Z-105
(2015)

PETITION NO.: Z-105

PROPOSED USE: Residential Senior Living (Non-supportive)

ZONING COMMENTS:

DATE: SEPTEMBER 4, 2015
DRAWN BY: [Signature]
CHECKED BY: [Signature]
SCALE: 1"=40'
CONCEPT SITE PLAN
SHEET NO. CP.2

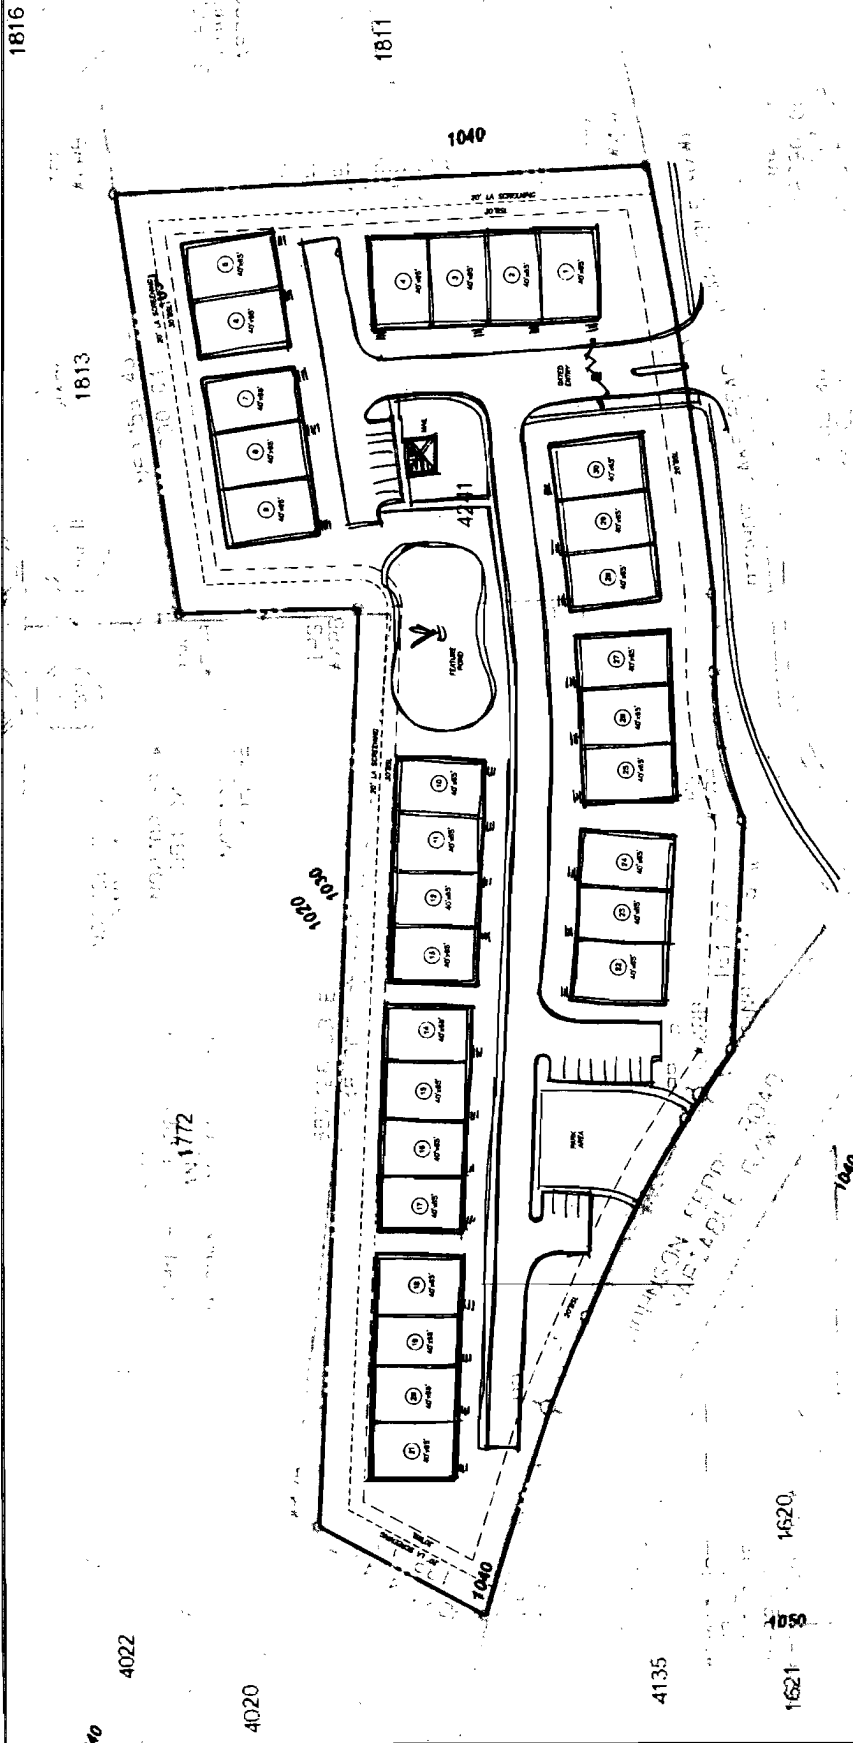
- Provide comprehensive hydrology/stormwater controls to include development of out parcels.
- Submit all proposed site improvements to Plan Review.
- Any **spring activity** uncovered must be addressed by a qualified geotechnical engineer (PE).
- Structural fill _____ must be placed under the direction of a qualified registered Georgia geotechnical engineer (PE).
- Existing facility.
- Project must comply with the Water Quality requirements of the CWA-NPDES-NPS Permit and County Water Quality Ordinance.
- Water Quality/Quantity contributions of the existing lake/pond on site must be continued as baseline conditions into proposed project.
- Calculate and provide % impervious of project site.
- Revisit design; reduce pavement area to reduce runoff and pollution.

- No Stormwater controls shown _____
- Copy of survey is not current – Additional comments may be forthcoming when current site conditions are exposed.
- No site improvements showing on exhibit.

1. This site is located just north of the intersection of Johnson Ferry and Bishop’s Lake Roads. Except for a very small area at the northeast and southeast corners, the entire site drains into and through the adjacent Wood Acres School site to the north. The existing conveyance through the school is not well-defined and will likely need to be improved to accommodate the increase runoff from the proposed development.
2. Downstream hydrograph routings will be required for the existing Wood Acres School detention pond as well as the culvert at Bishop’s Green Drive at Plan Review to verify no adverse impact at these structures.
3. A 20-foot drainage easement will be required along the rear of lots 10-21 to direct site runoff to the proposed detention pond and to limit runoff bypass from the site.

Recommend a deceleration lane on Bishop Lake Road for the entrance with the length to be determined during plan review.

Recommend curb, gutter, and sidewalk along the Bishop Lake Road frontage and connect to the sidewalk on Johnson Ferry Road.

Recommend the proposed gate meet Cobb County Development Standards.

- Board of Commissioners to approve final site plan, with the District Commissioner approving minor modifications;
- Maximum density of 2.5 units per acre;
- Fire Department comments and recommendations;
- Water and Sewer Division comments and recommendations;
- Stormwater Management Division comments and recommendations;
- Department of Transportation comments and recommendations; and
- Owner/developer to enter into a Development Agreement pursuant to O.C.G.A. §36-71-13 for dedication of system improvements to mitigate traffic concerns.
